Hi-Fi Products
Service Bulletin

Model: TC-K620/K650ES/K670/K677ES/K690/K679ES No. 275R1

Subject: Tape Gets Wrinkled

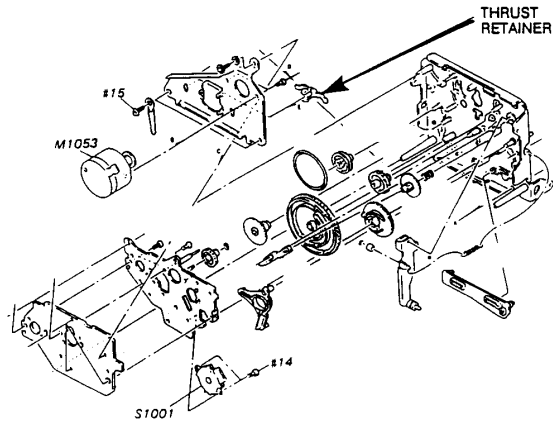
Symptom:
(65)

The tape gets wrinkled by the capstan and pinch roller. The thrust retainer for the flywheel gets deformed so that the shaft of the capstan easily moves back and forth causing unstable tape path during play.

Solution: Replace the thrust retainer with the new type as shown in the chart below:
